917 NE 63rd St

3039964-LU
Northeast Design Review Board
Design Recommendation Meeting
December 4, 2023

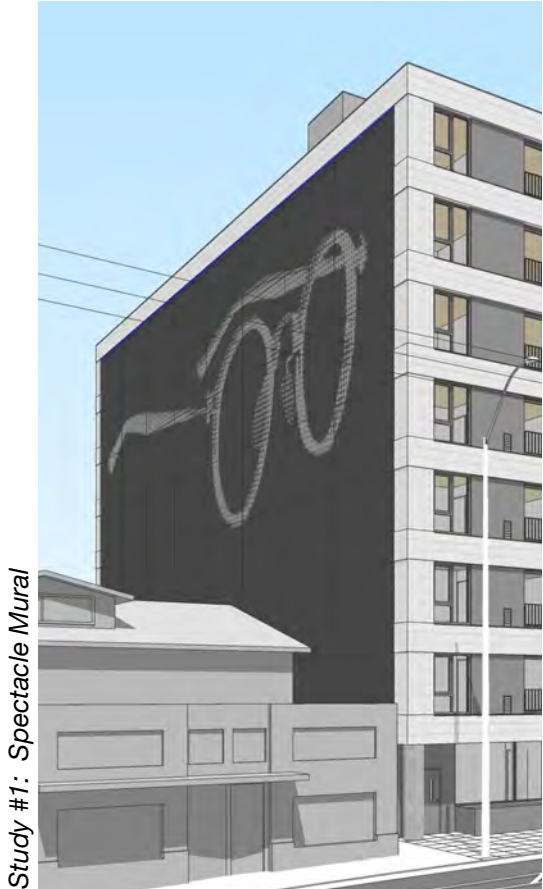
- b. The Board requested images and illustrations depicting the *existing commercial development adjacency to the south and its relation to the proposed development*. The Board expressed concern for the *potential blank wall condition of the south façade* and requested the applicant to explore employing a consistent framing design along Roosevelt Way NE, across the south façade, and onto the alley-facing facade for conceptual consistency across all facades. (CS2-B Adjacent Sites, Streets and Open Spaces, DC2-B Architectural and Façade Composition)

- The existing commercial development to the south will benefit in two ways from this new development: 1) the ground floor façade is pulled back more than 9' due to the combination of the approx 4'-9" required building setback and the additional 4'-4" ground level setback making the existing retail more visible from the north. 2) this project is including ground floor commercial (though not required by zoning) which will help pull the commercial energy from 65th further down Roosevelt adding to foot traffic and visitors to the block (CS2-B Adjacent Sites, Streets and Open Spaces).

- Architecturally, the existing retail to the south of the site is of a similar height to the new commercial space. The pedestrian experience along the street will continue uninterrupted from old retail to new retail and greatly improved from the addition of overhead weather protection, widened sidewalks and added street trees (PL3-II Human and Commercial Activity).

- With the site's proximity to transit and the Roosevelt light rail station, it is likely the southern portion of the block will be developed in the next few years, covering up the southern facade completely. Despite the probability the southern party wall will be hidden from view, the design team has responded to the interim condition and continued the use of high quality brick around the entire southern wall perimeter. The 3' brick frame element wraps all four edges of the southern facade, which ties the southern elevation to the other three (DC2-B Architectural and Facade Composition).

- In addition, the design team is currently studying adding art, graphics or signage to further activate the southern facade (see three studies).
- Because Roosevelt is a one way street headed southbound, the southern facade will not be a prominent feature of the building experienced by most people passing by which is why the design team has decided on a restrained, but high quality facade composition that relates to the rest of the building.

View looking SE

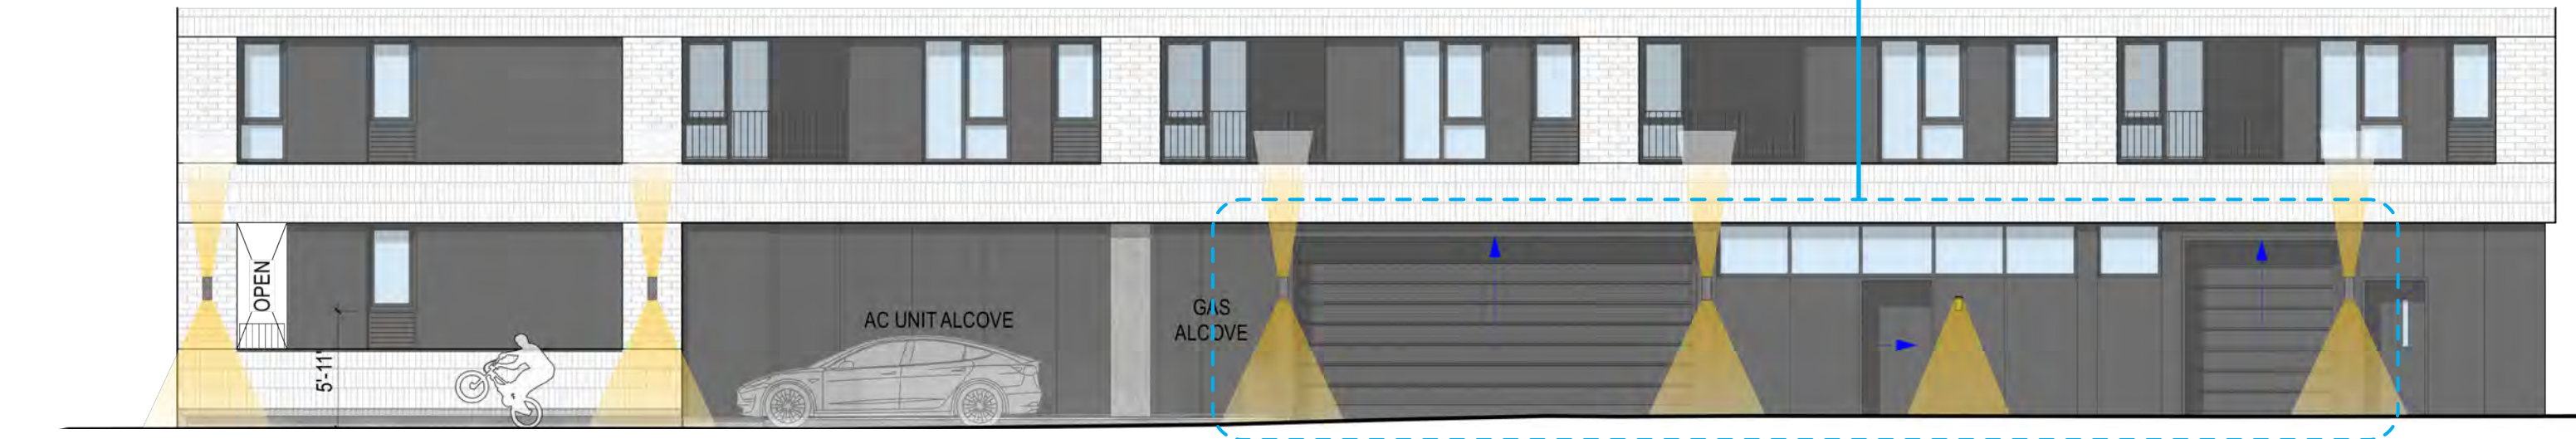
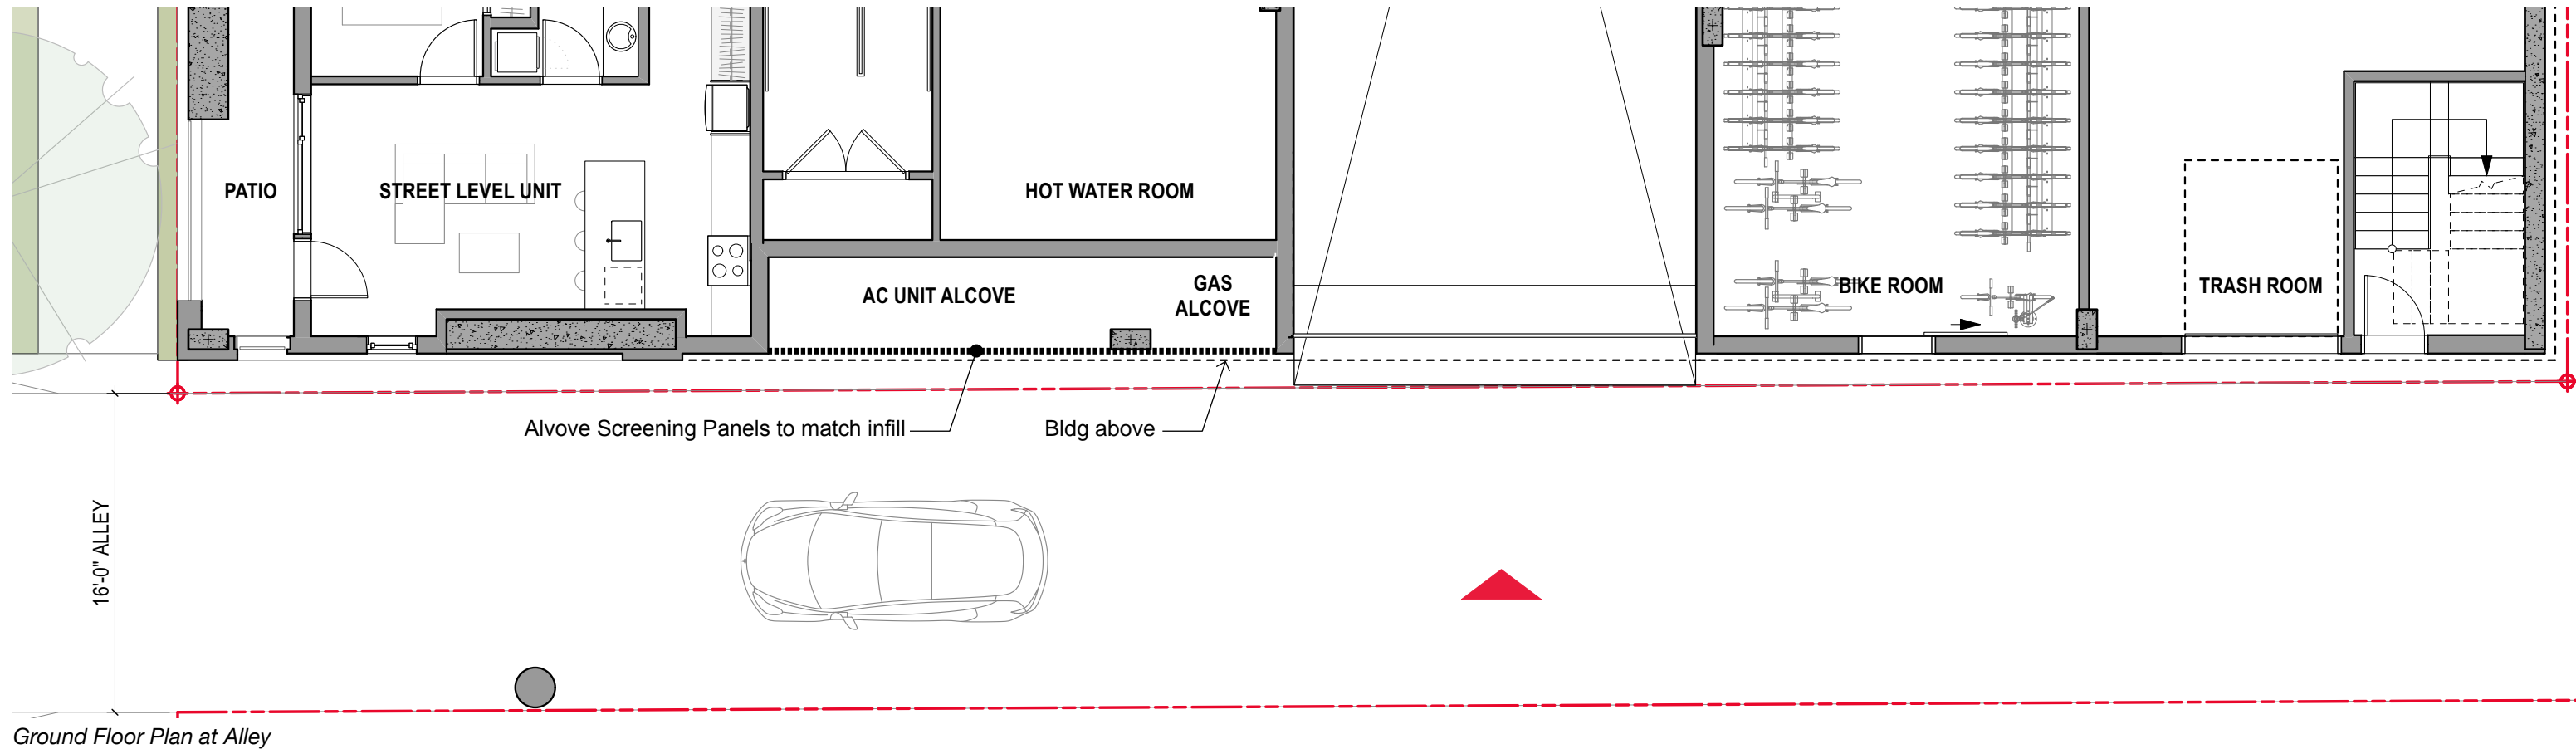
- c. Additionally, the Board requested additional information about the alley conditions to better assess the potential impacts of the design on adjacencies. Specifically, the Board would like illustrations, perspectives, and measurements to better understand how the *ground level programming and the proposed balconies relate to the alley and alley-adjacent development*. (CS2-B Adjacent Sites, Streets and Open Spaces, DC2-B Architectural and Façade Composition).

- Along the alley at ground level is a ground floor unit, garage ramp, access to bike room, trash room and one exit stair door. High windows have been added to the bike room and trash room to let in light and safely activate the alley (CS2-B Adjacent Sites, Streets and open Spaces).

- The NW corner is activated by the ground floor units with windows, patios, and high quality materials (brick) turning the corner.
- The design team is also studying additional alley activation through the use of graphics, art and sigange (see sketch study to the right).

- The alley is already fully built out to the 16’ width required. Additionally, the power line running down the alley on the west side results in a significant separation between the new development and any future development across the alley (see section below).

- The west façade of the building responds to its context and the lower scale across the alley by inseting balconies to soften the scale transition.
- The west façade design, composition and materials are in keeping with the other façades, but responds to its unique context within the common design language of the cohesive building (DC2-B Architectural and Façade Composition).

VIEW LOOKING AT COURTYARDS

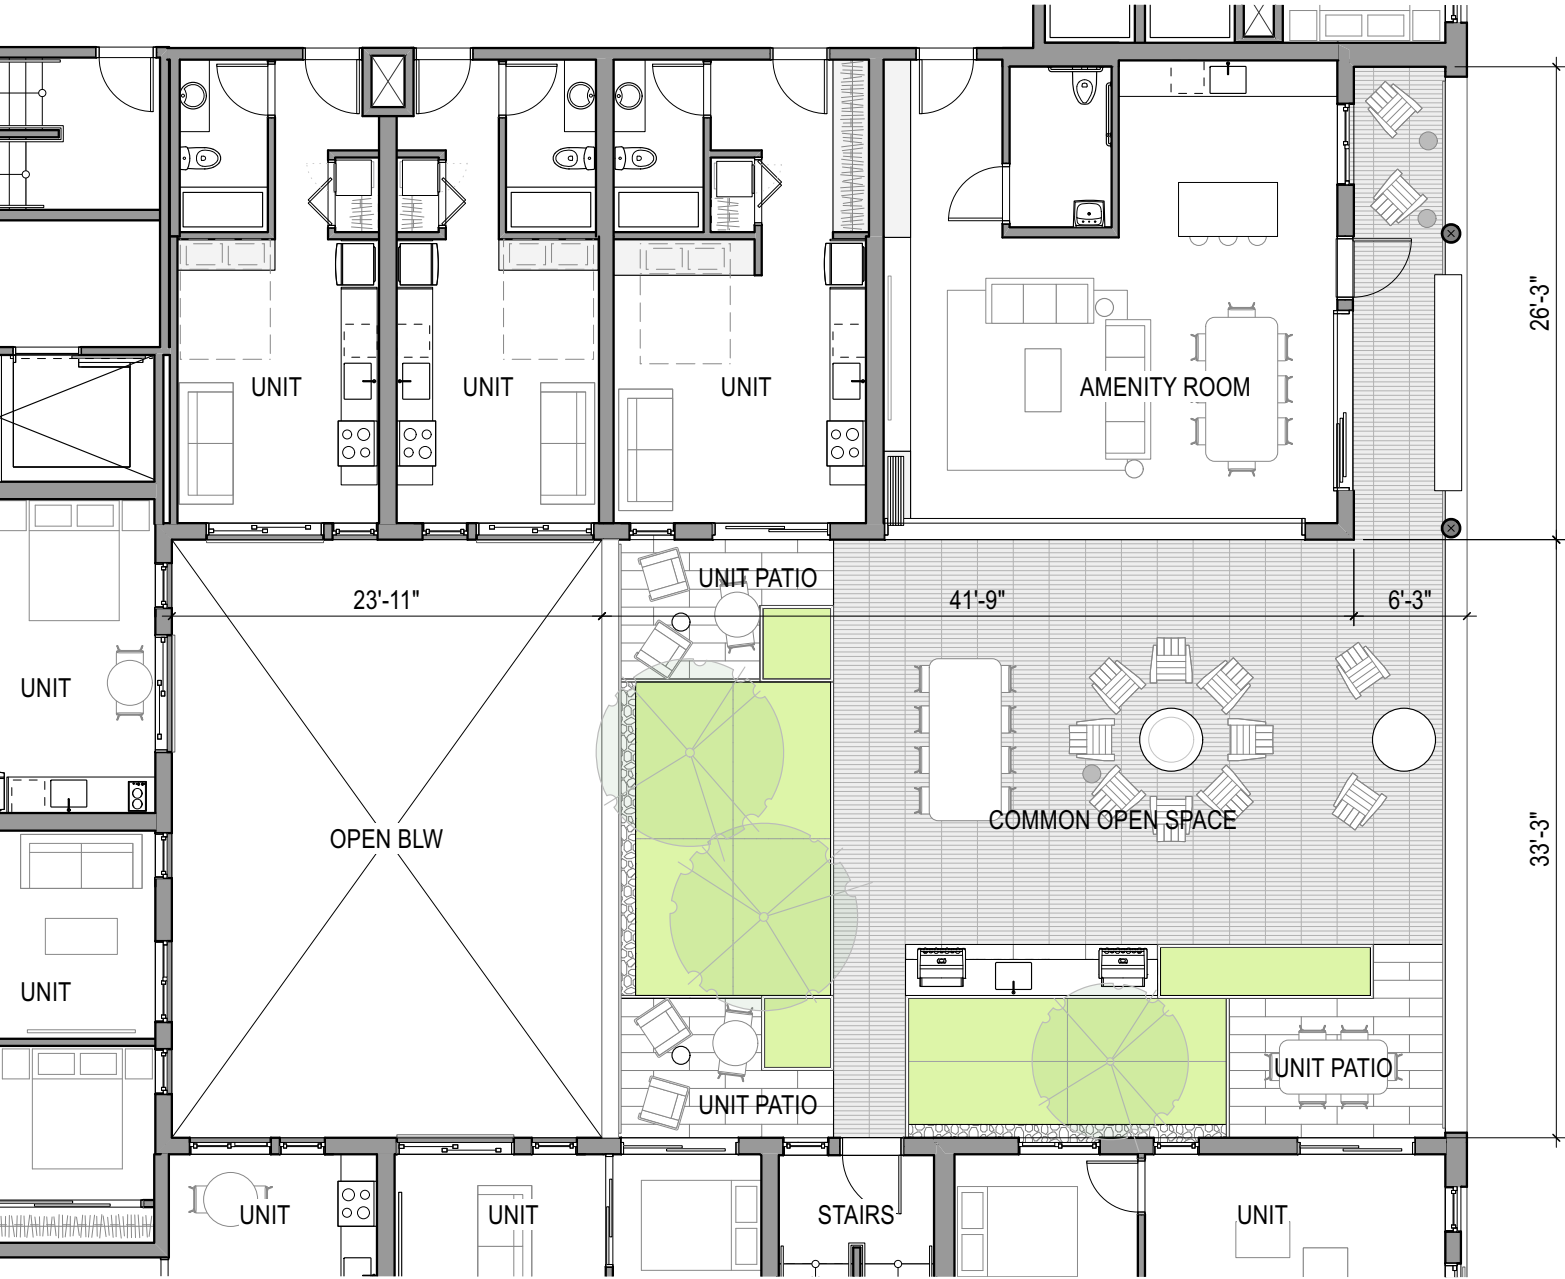
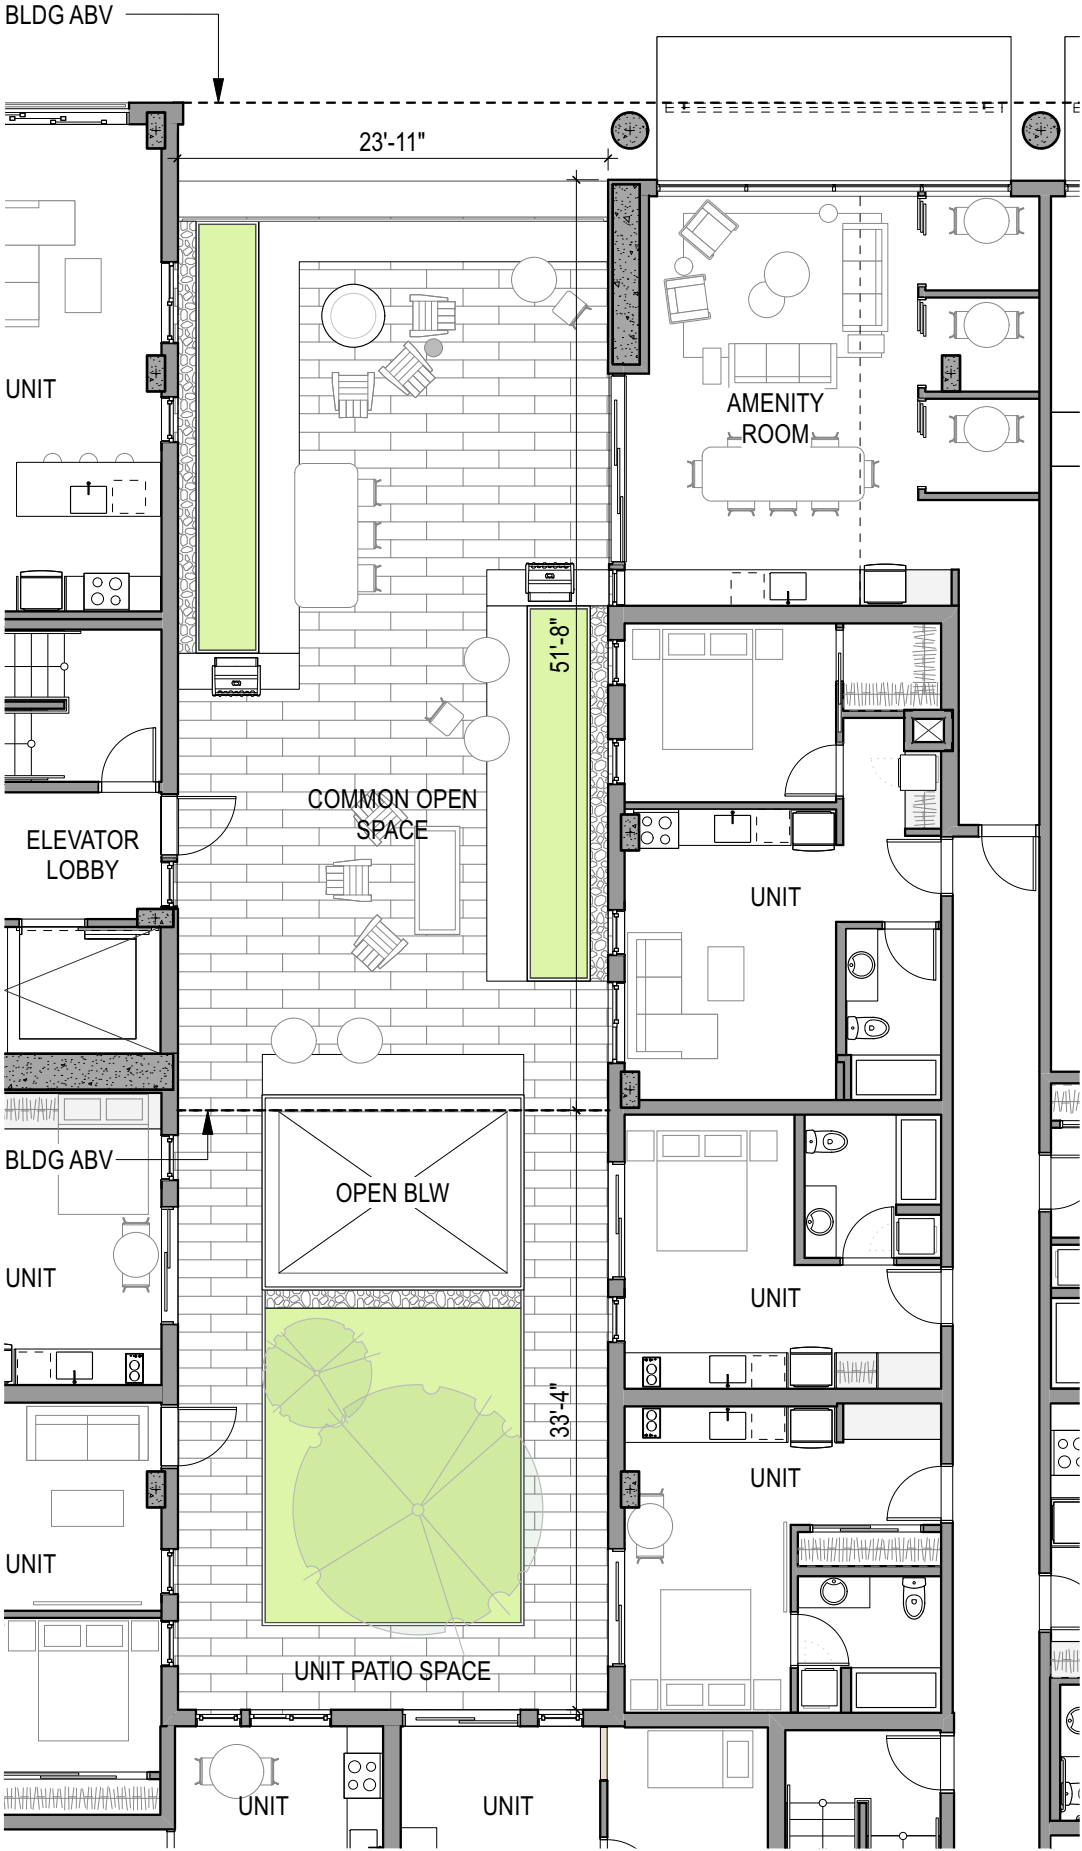
d. The Board requested additional information about the *dimensions and design of the open spaces and courtyards* to better understand how and to what extent residents will have access to sunlight and natural ventilation. (PL2-C Weather Protection, DC2-A-1 Site Characteristics and Uses, Roosevelt Guidance DC3-I-I Views and Solar Access)

- Every unit has multiple windows – most living rooms have two windows each to increase light and air penetrating into the units. No units are deep shoeboxes, but rather shallower units with plenty of exterior skin access (DC3-I-I Views and Solar Access).

- The courtyards allow all units to have plenty of light and air access as can be seen in the plans, sections and 3D images on this page and the next three pages. Dimensions are provided on the plans.

- Though some of the units will not have direct sunlight hitting their windows, that is a common urban condition where tall buildings block direct sun, but there is plenty of bounced, indirect sun. The courtyards offer views, vitality and interest for residents to look out on from their units.

- In addition to the light and air enjoyed within each unit, residents will have shared access to not just one but three outdoor spaces at levels 2, 6 and the roof, each offering unique space. Level 2 will provide covered outdoor space that will allow it to be used all year round (PL2-C Weather Protection).

- Level 2 and 6 courtyards each have an amenity room that opens up to the outdoor space providing all year options for residents.
- The protected, covered courtyard at level 2 allows for outdoor socializing even in the winter months and is a smaller scale, cozy space off the work from home lounge.
- The larger open to the sky space at level 6 provides indoor outdoor spaces but is still protected from some of the wind forces.
- Planting has been strategically placed to allow for privacy to units while creating a vibrant, communal social space for residents and their guests.
- Both courtyards will have active edges with seating or planting that will be visible from the street adding to the activation and vitality of both Roosevelt and 63rd (DC3-A Indoor-Outdoor Concept).
